**AGENDA
CITY OF CEDAR FALLS, IOWA
PLANNING AND ZONING COMMISSION MEETING
TUESDAY, NOVEMBER 24, 2020
5:30 PM AT CITY HALL VIA VIDEO CONFERENCE**

TO: Planning & Zoning Commission
FROM: Jaydevsinh Atodaria (JD), Planner I
DATE: November 19, 2020
SUBJECT: The Autumn Ridge Master Plan Amendment

MASTER PLAN - AUTUMN RIDGE 9th AND 10th ADDITIONS CEDAR FALLS, IOWA

TO: Planning & Zoning Commission
FROM: Jaydevsinh Atodaria (JD), Planner I
 Matthew Tolan, Civil Engineer II
DATE: November 19, 2020
SUBJECT: The Autumn Ridge 9th Addition Preliminary Plat

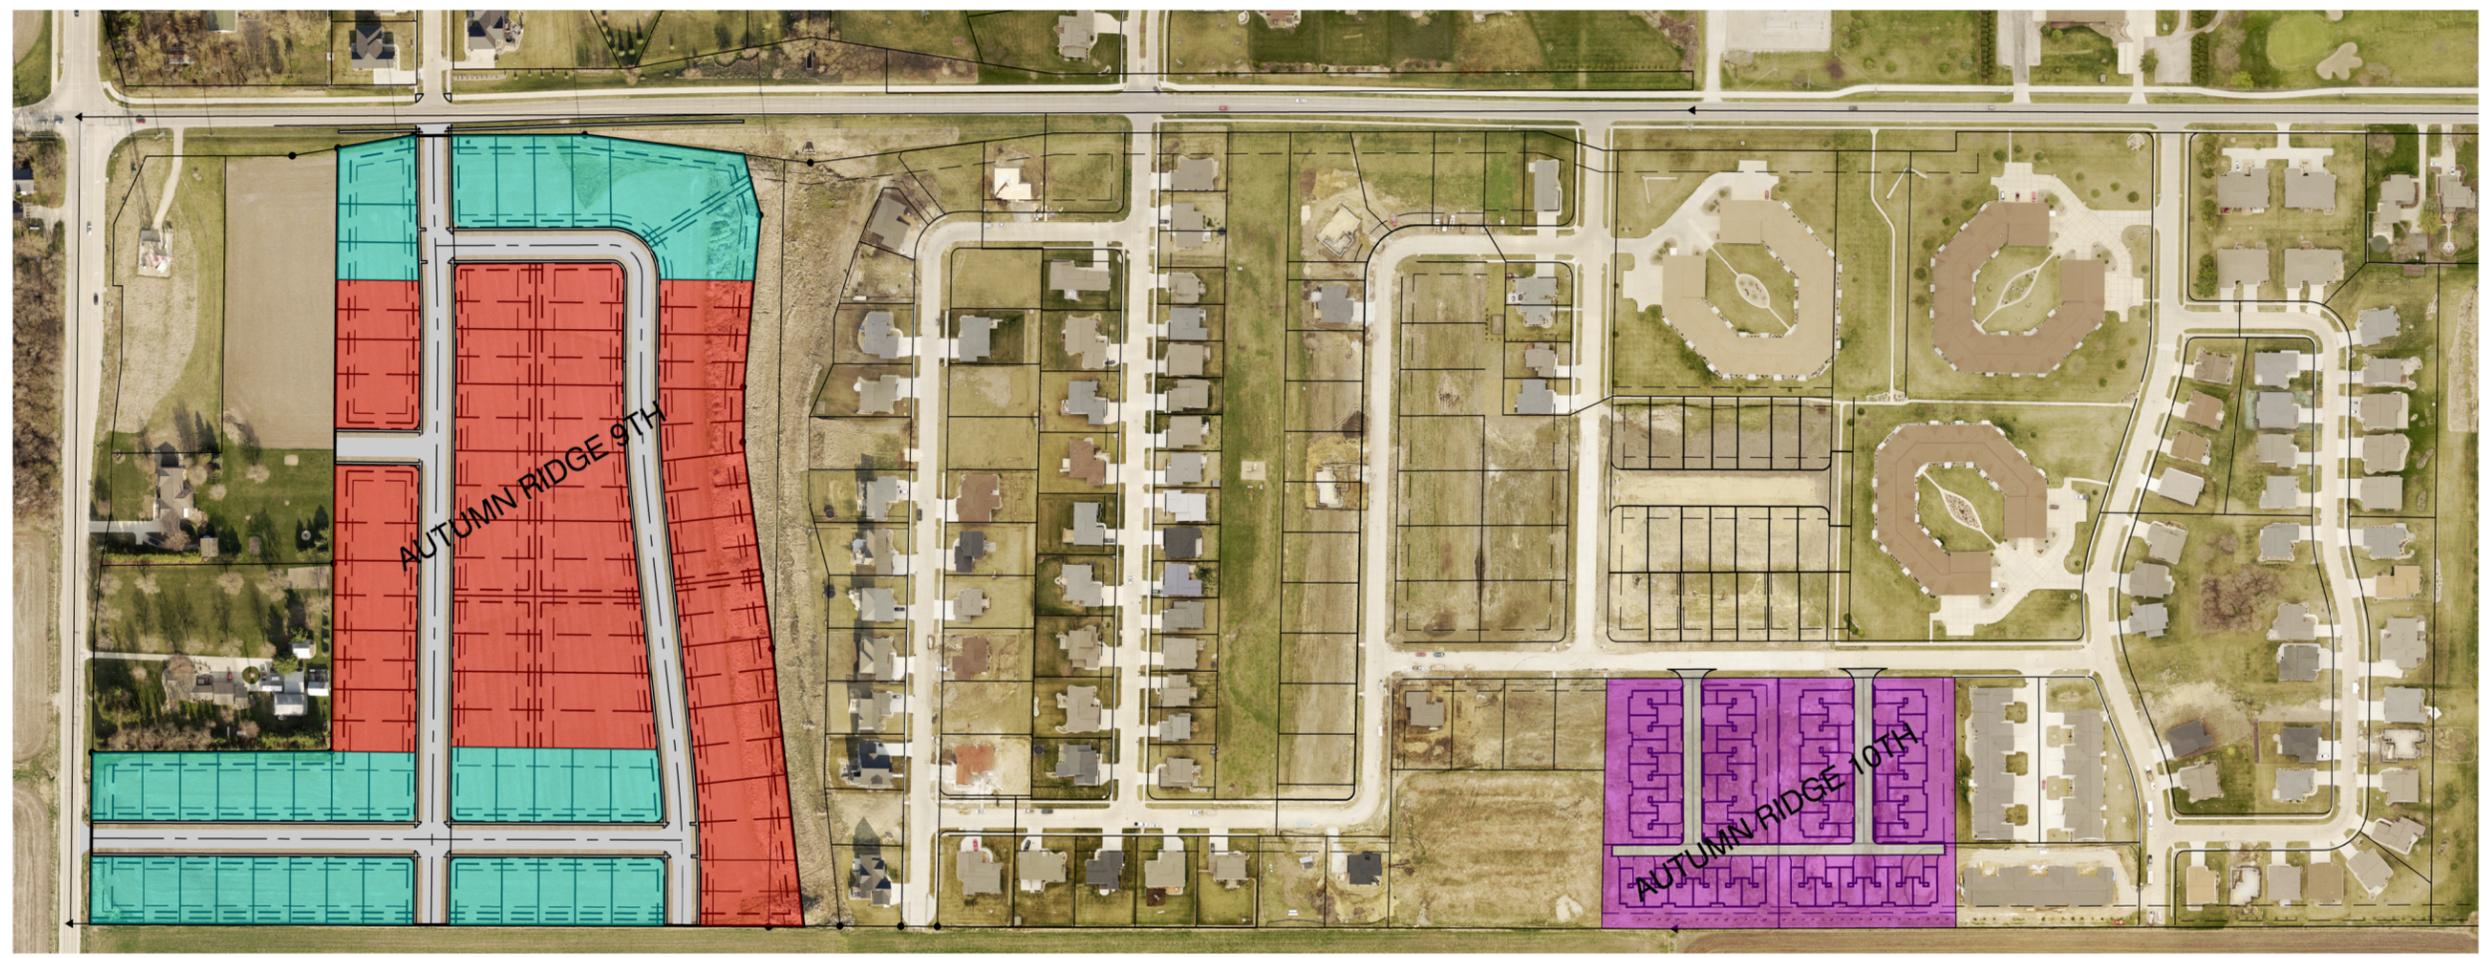
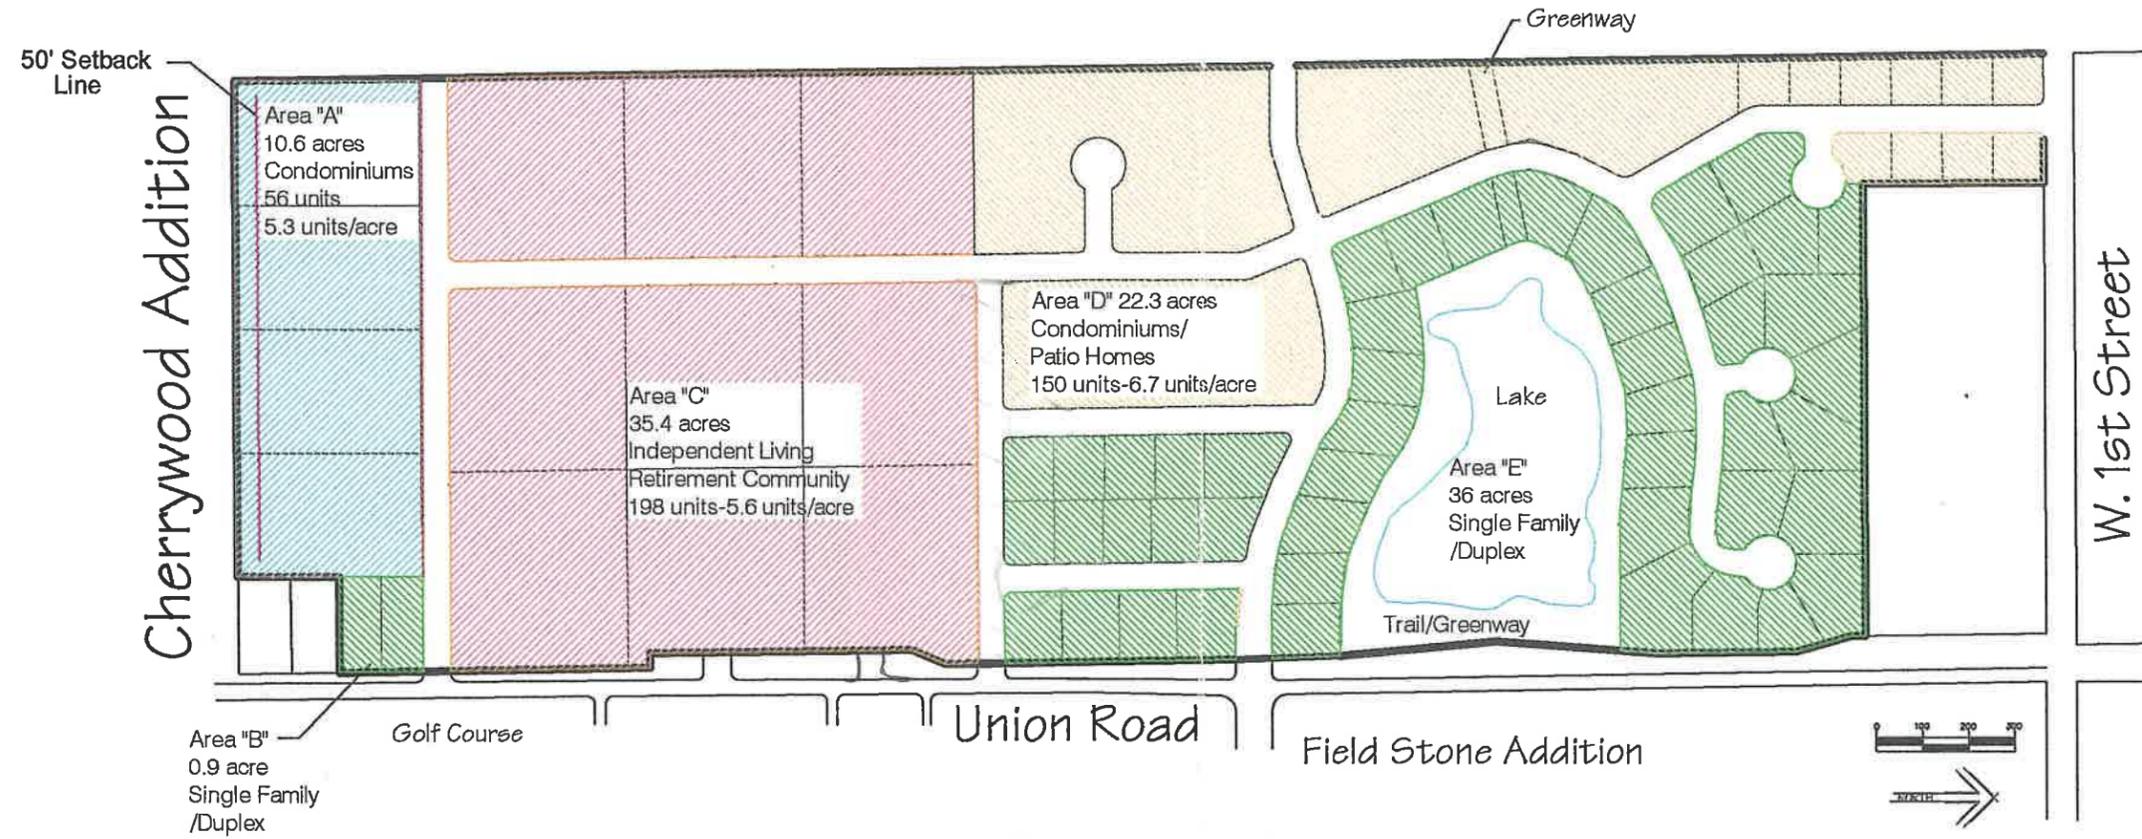
The Master Plan exhibit submitted with the application highlights the two proposed additions (9th and 10th) in the subdivision in context with the rest of the development in Autumn Ridge. The updated RP master plan proposed by the developer is described below, with areas of change from the original plan highlighted and staff recommendations noted.

The developer is proposing to increase the number of bi-attached dwellings and reduce some of the lot sizes for the single family units in the proposed Autumn Ridge 9th Addition in response to market demand. The City supports the idea of additional density and a variety of housing types to serve the needs of the community. The proposed master plan transitions from single family homes along the perimeter of the development along Union Road and along the western boundary of the development with bi-attached homes proposed in the center of the 9th Addition.

The developer has indicated that they would like to move forward with the proposal as currently designed with no limits on driveway widths or curb cuts and is not interested in providing alley-loaded, townhouse-style units. While supportive of the proposal to increase the number of dwelling units in this area, City Staff finds that the current proposal is not a good planning practice model for the community and not in line with concept of the RP Zoning district intent of providing high quality living and enhancing health and safety of people in neighborhood and recommends exploration of other options or solutions for maintaining the residential character, on-street parking space, and walkability along the streets

While staff is not opposed to the elimination of the wet-bottomed stormwater basin (lake), elimination of the shared open space and amenities entirely is not recommended. The developer has not indicated an alternative to the open space proposed in the original master plan and as agreed to in the developmental procedures agreement. While some shared green space was designated behind the homes that front on Paddington Drive and Shocker Road, it is not configured in a way that is very accessible or usable for residents of the entire neighborhood. In addition, since the plan changed to eliminate the street connection originally proposed to cross the drainage way at Corduroy Drive, the northern area is now cut off from any amenity space located in the southern portion of the development. Therefore, City staff recommends that some usable open space be designated within the 9th Addition as originally agreed. Planning staff has reached out to the Parks Department to see if public park space would be desirable in this area. More information in this regard may be available at the time of the meeting on Tuesday.

The Community Development Department has reviewed the proposed master plan and recommends the following changes to the proposed RP Master Plan for Autumn Ridge, prior to approval:

PRELIMINARY PLAT - UTILITIES AND EASEMENTS

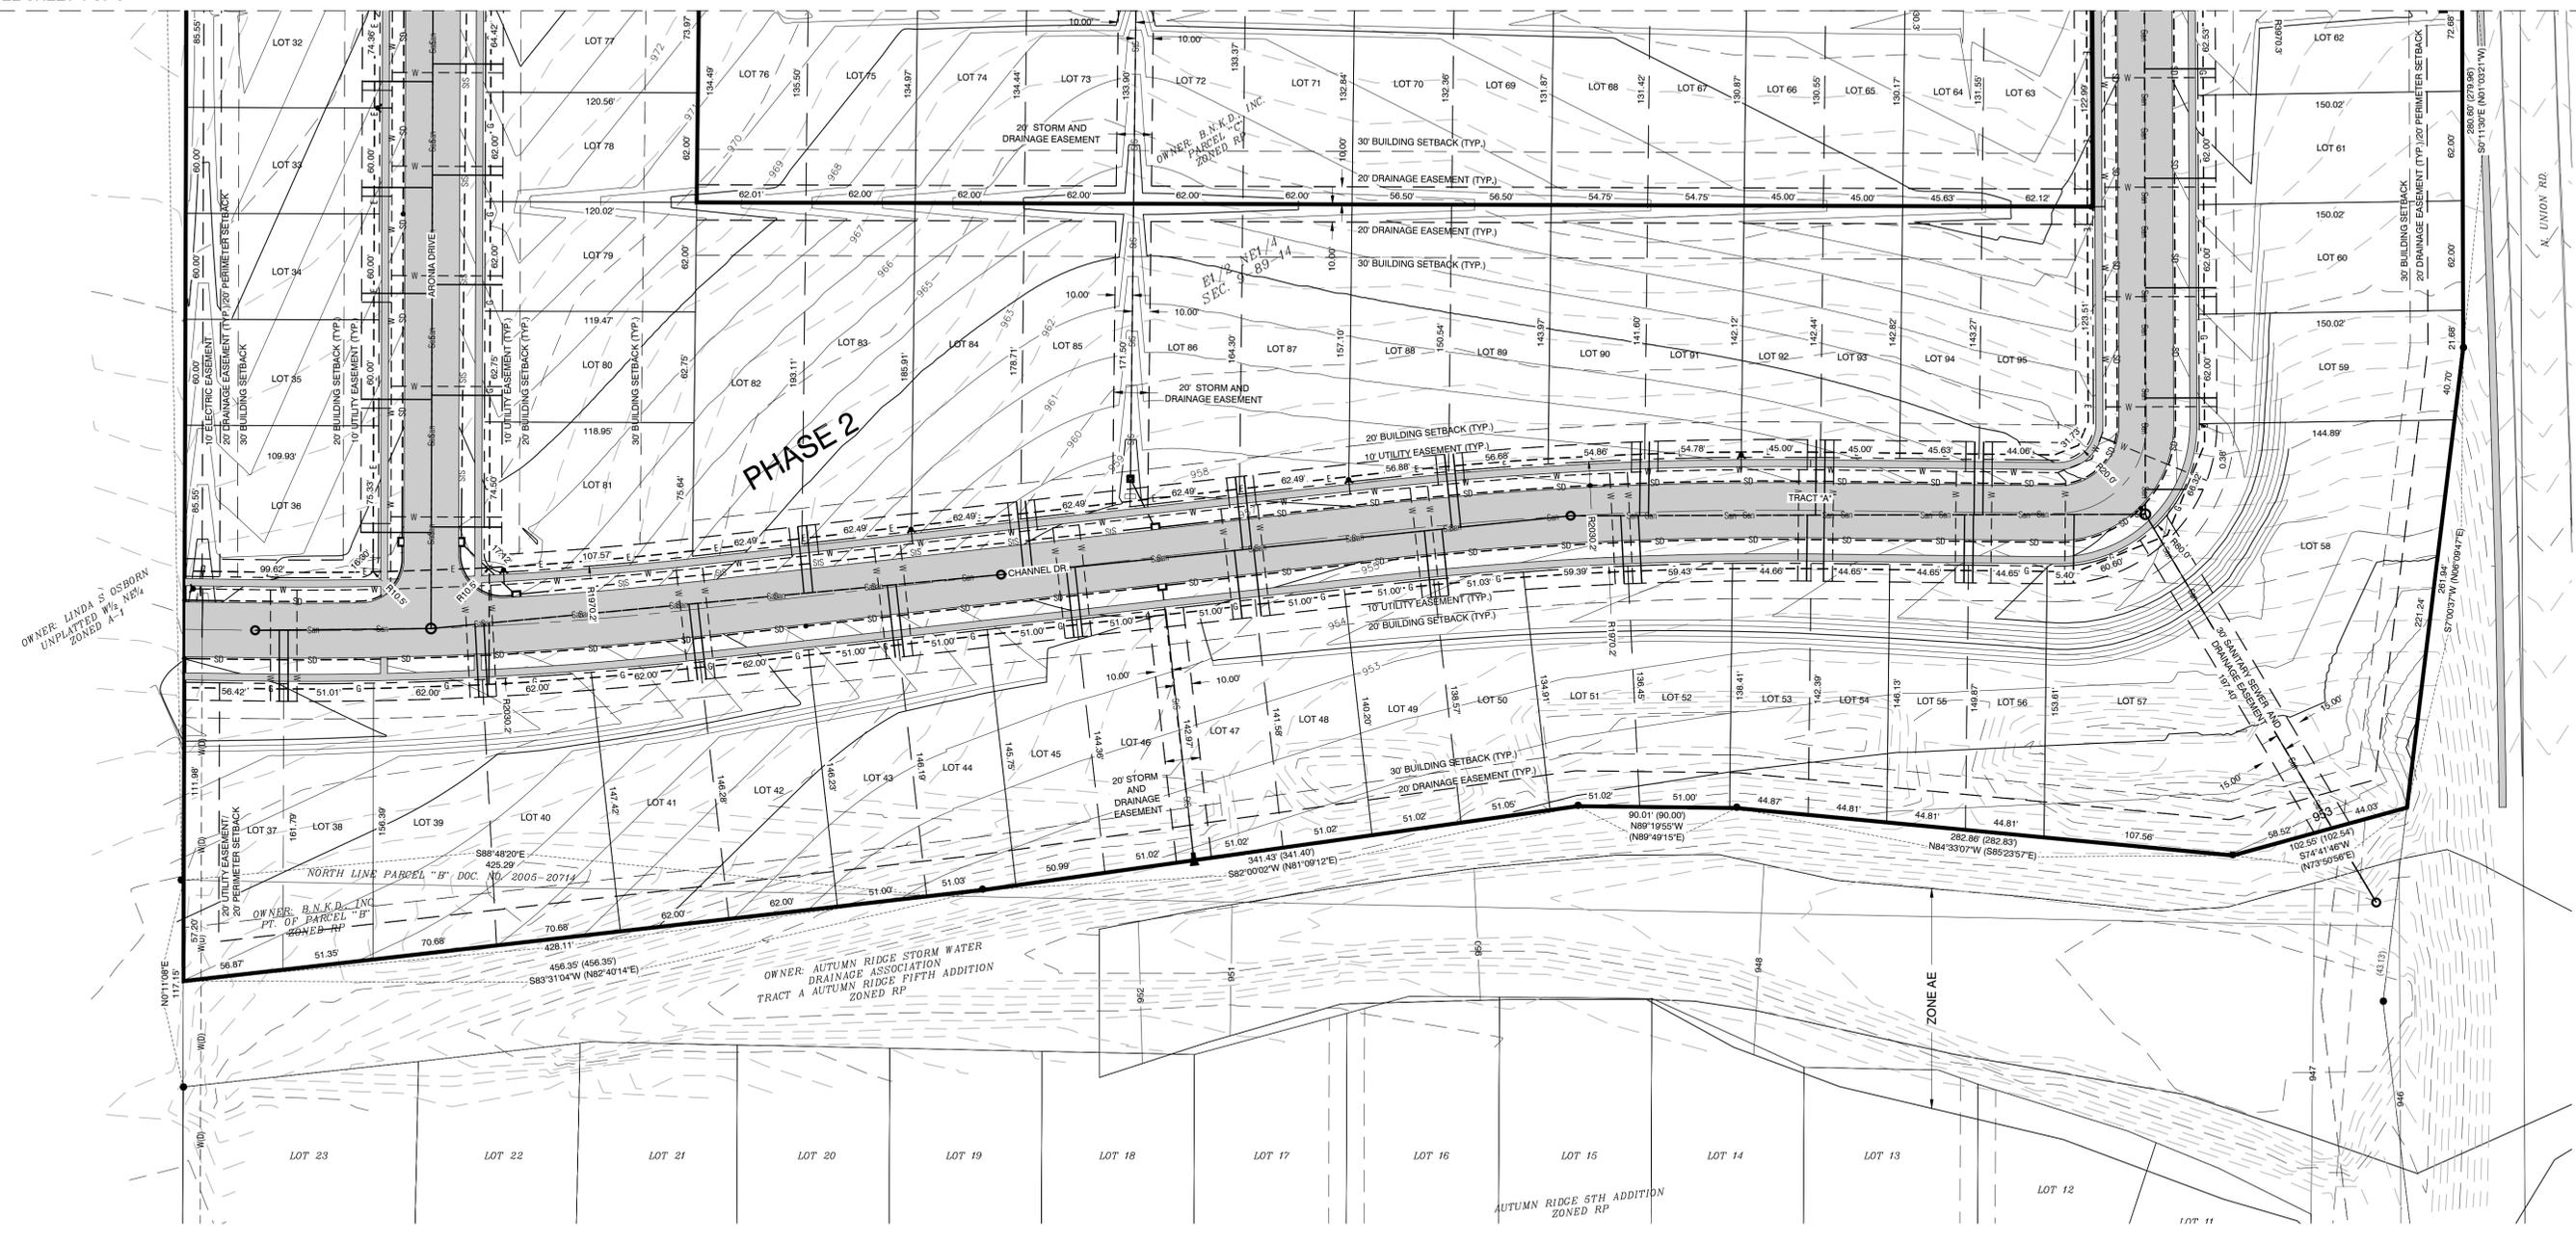
The 20' Drainage Easement needs to be change to a 20' Drainage and Utility Easement in the following locations: along the north side of the addition, including lots 1 through 15; the northeast corner of lot 17; along the east side of lots 18 through 23; along the west side of the entire addition, including lots 24 through 37; along the south side of the entire addition, including lots 37 through 58; and along the east side of the addition, including lots 58 through 62.
